Subject: Additional Information Concerning the ALWR Report
"Qualification of PARs for Combustible Gas Control in ALWR s,"
April 8, 1993

ALWR ANSWERS TO QUESTIONS ON PARs
FROM
SANDIA NATIONAL LABORATORIES

December 21, 1993

Bild 7-8: ⁰⁻¹⁹ Vergleich der Approximationsfunktion mit den Meßdaten; Versuch M: 1.2.3 (CO)

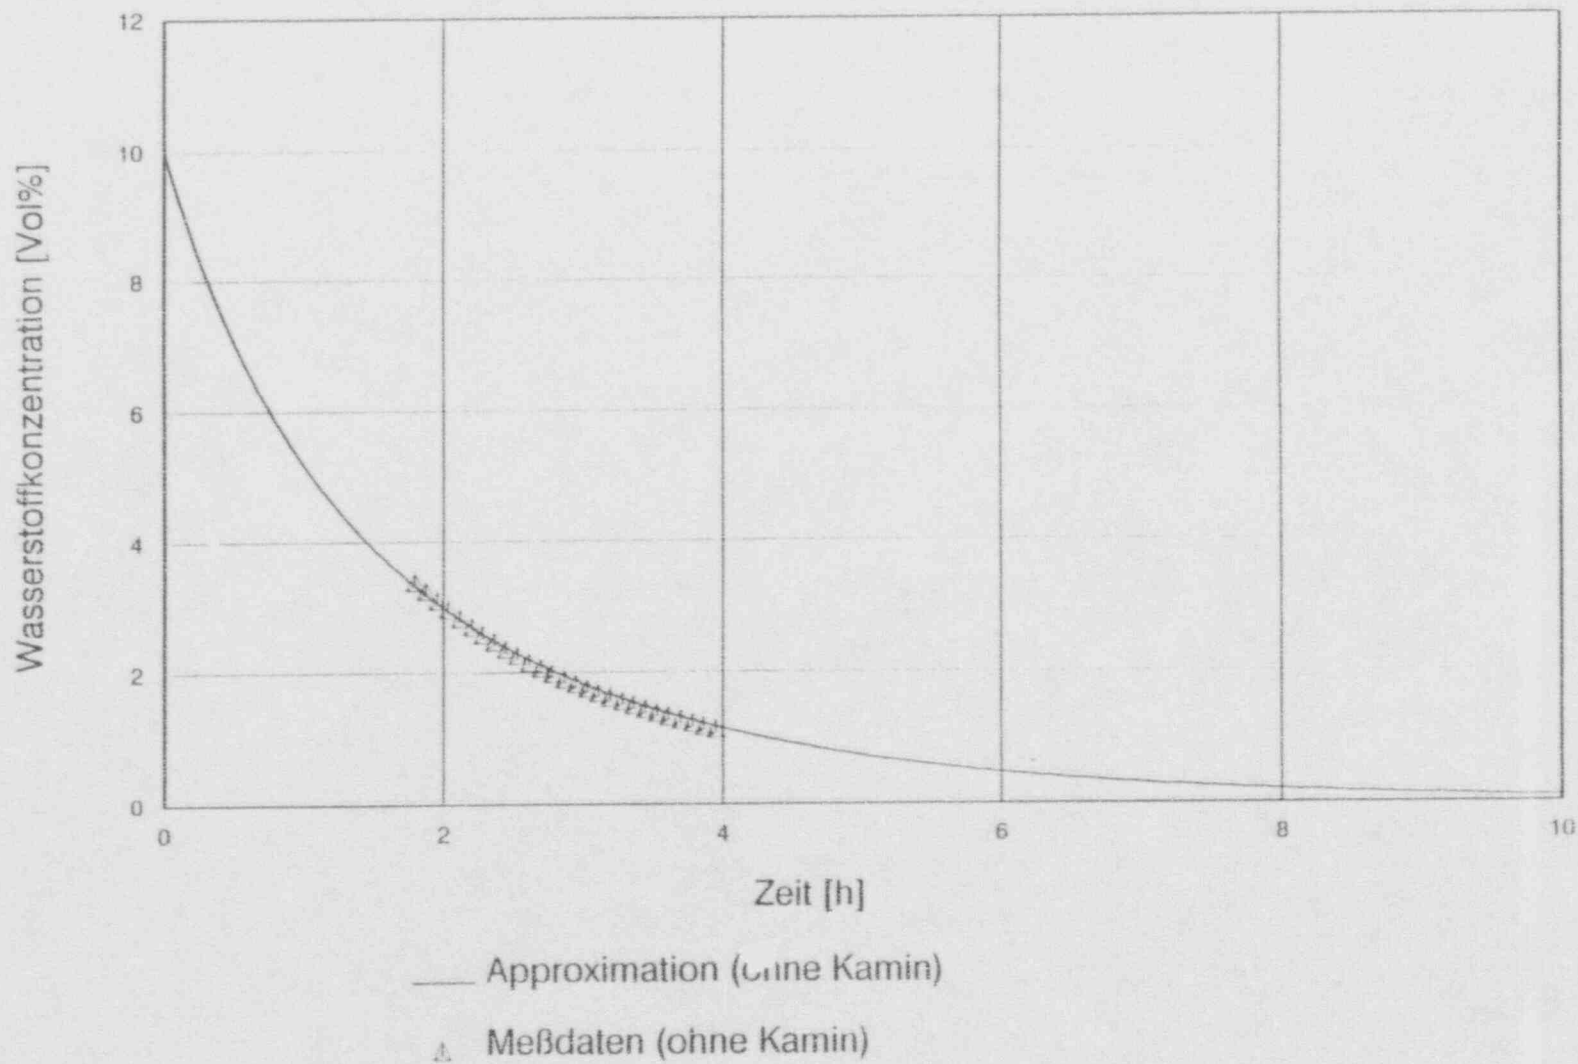
15. Page 57, last paragraph. What room does the data in Fig. C-10 apply to? If it applies to all the rooms, how was the measured curve derived?

The variable plotted in this figure is the average concentration of all the rooms included in the experiment. It was created electronically by combining the signals from all rooms (the blips in the curve are electronic disturbances of some sort).
